**Major Site Plan Application**  
**S&N Investments LLC**  
**Proposed Tier 3 Marijuana Cultivation Facility**  
**24 Gambo Road**  
**Windham Assessor's Map 41, Lot 4**  
**Response to Comments**

### **Response to Staff Comments Received June 16 and 17, 2021**

## Pond 1P: Grassed UDSF

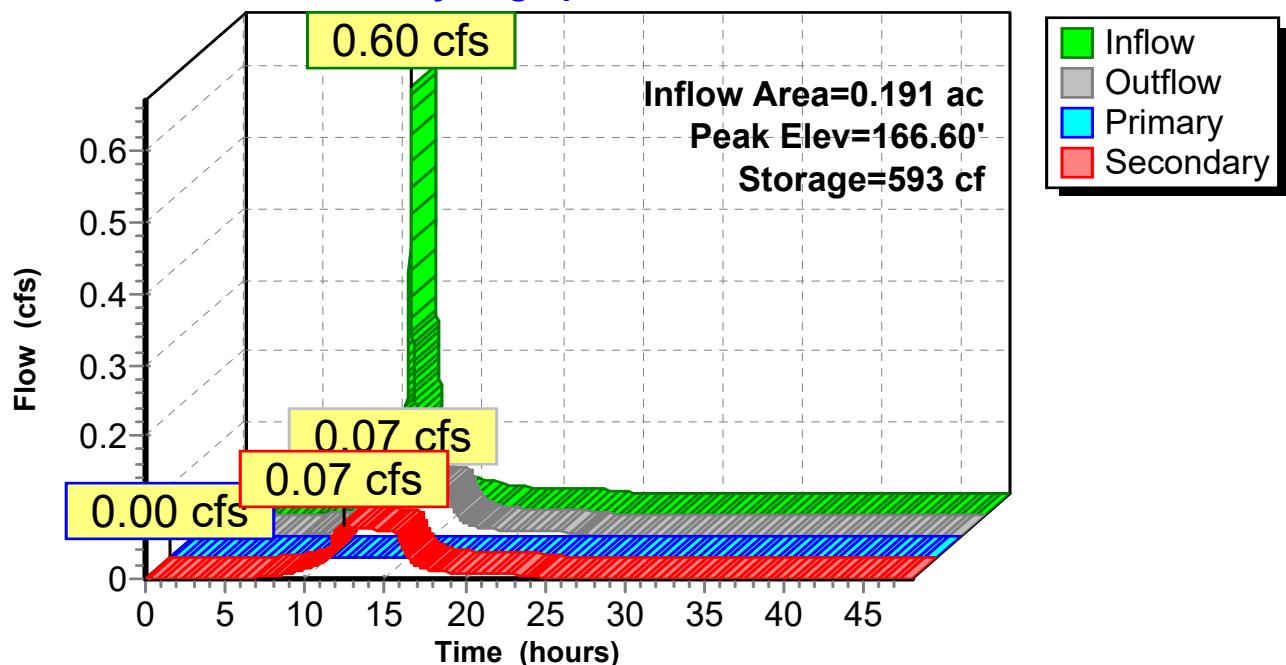
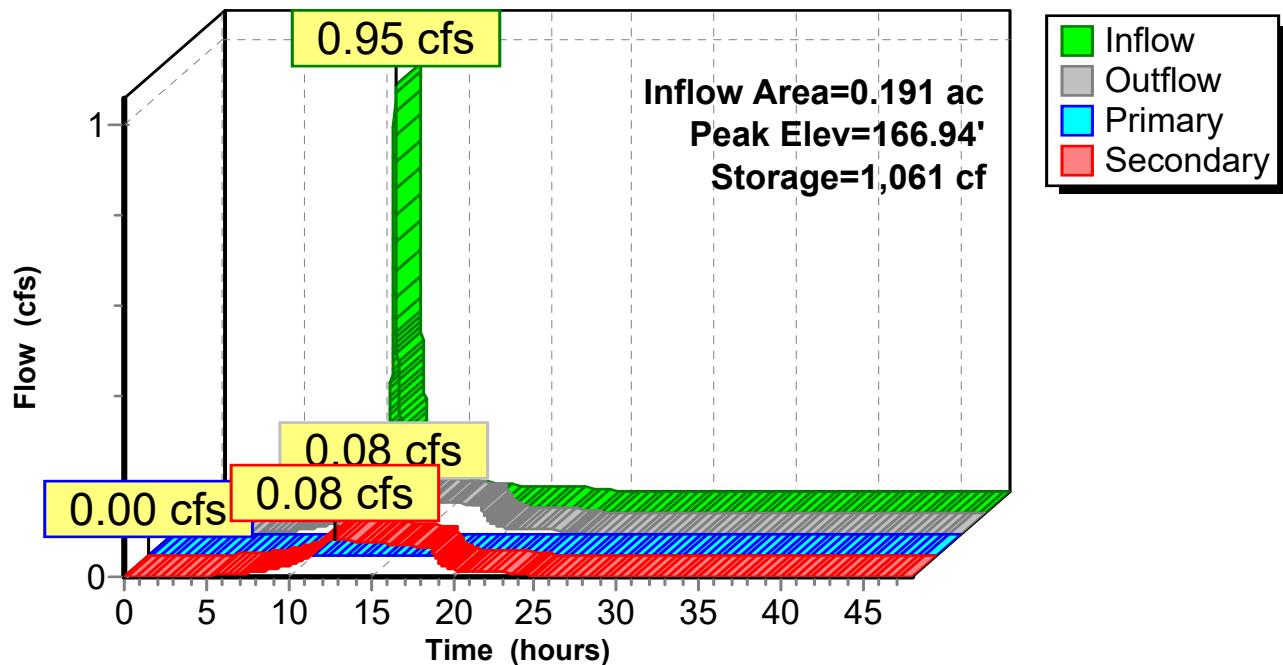
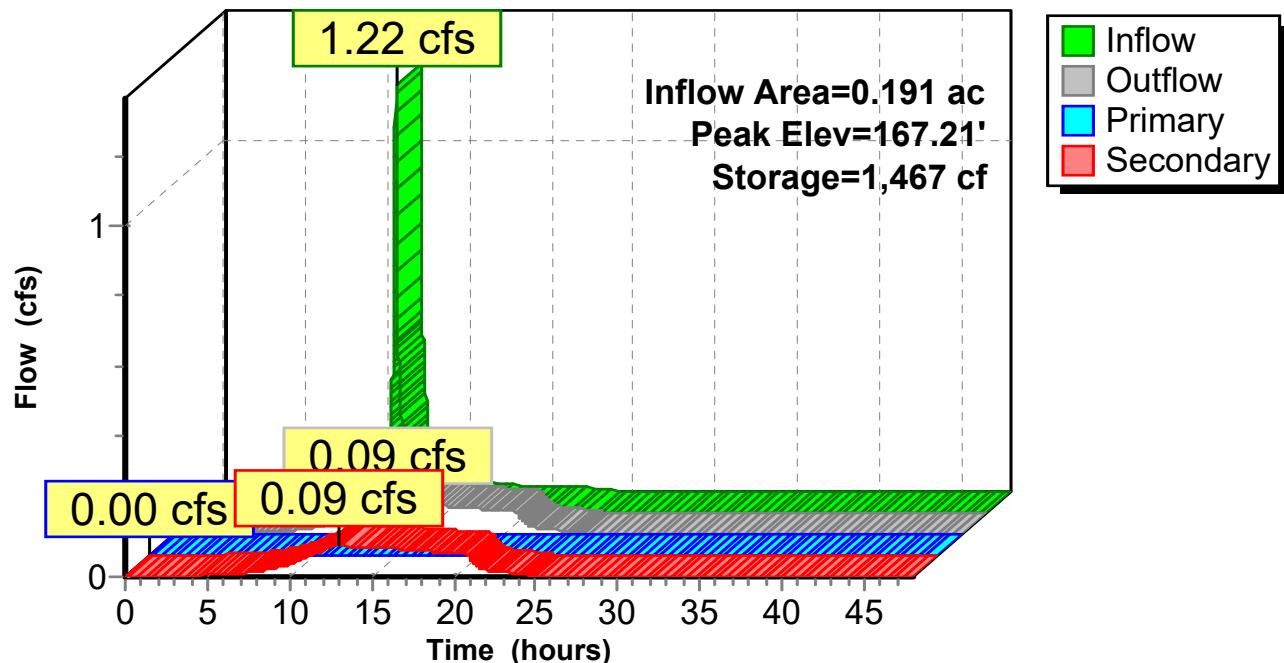
- *The Maine DEP requirements for a UDSF is that it must drain the stored volume in no less than 24 and no more than 48 hours. The stormwater modeling results provided in the application seem to indicate that the basin will drain in less than 24 hours. The Applicant should clarify.*

- Our office has reviewed and revised the Stormwater Model for the proposed Grassed UDSF to assess the timing for the basin to drain. In the prior model, the proposed underdrains were inadvertently overlooked in the modeling data. In addition, the phase-in depth for the exfiltration was corrected to reflect the base of the Grassed UDSF. Please note that the perforated underdrain size has been revised to 4" in the base of the BMP. Although these changes had no effect on the overall peak discharge rates previously calculated at Study Point 1 during each storm event, there were minor changes in the predicted water surface elevations in the Grassed UDSF and the time to drain the BMP equates to 24 hours.

In reviewing the table (non-shrunk) for the hydrograph results for the revised modeling, it shows that, in the 2 year storm event, the secondary flow from the filter ends at approximately 24 hours, which is within the MDEP's 24 to 48 hour timeline for pond drainage. We have enclosed a pdf print out of this hydrograph data.
